Re: DEP File Number 1050059-053-AC
Changes to Previously Established Federally Enforceable Conditions
DAP Plant No. 2 Minimum dP Requirement for Venturi Scrubbers
Incompleteness Items

The department received your application for an air construction (AC) permit on August 14, 2006. The application is for changes to previously established federally enforceable conditions. The request contained nine (9) specific items originating from prior AC permits. Eight of the 9 items will be processed under File No. 1050059-052-AC. The remaining item will be processed independently as File Number 1050059-053-AC.

Subject: Construction Permit Application
Mosaic Fertilizer, LLC - New Wales Facility
Facility No. 1050059

Comparison of Individual Run Venturi Pressure Drops vs. Tested Emissions

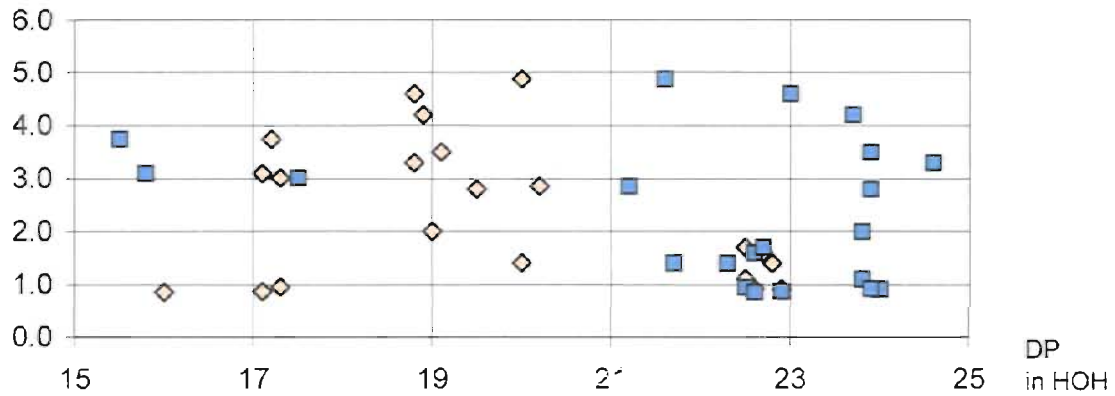
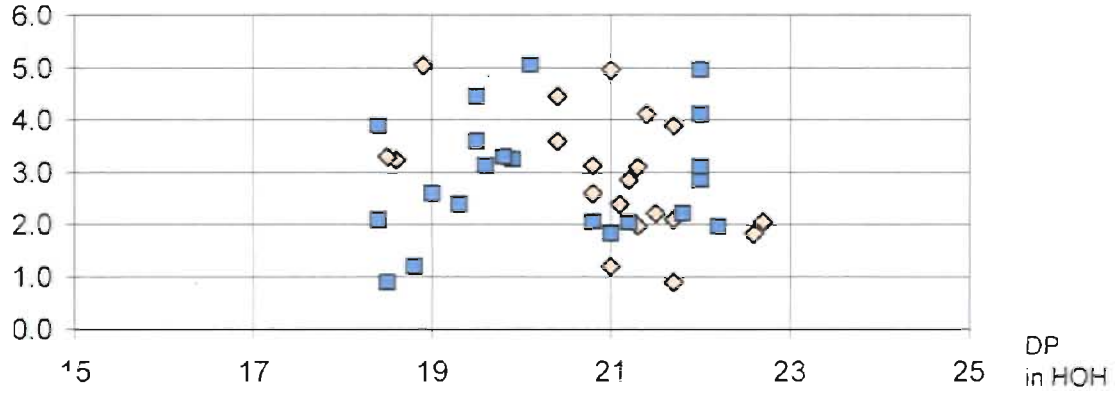
This shows that the PM emissions aren't strongly related to the Venturi pressure drops. Because the PM limits are so stringent, any changes would not be significant. Please advise if you need any additional information.
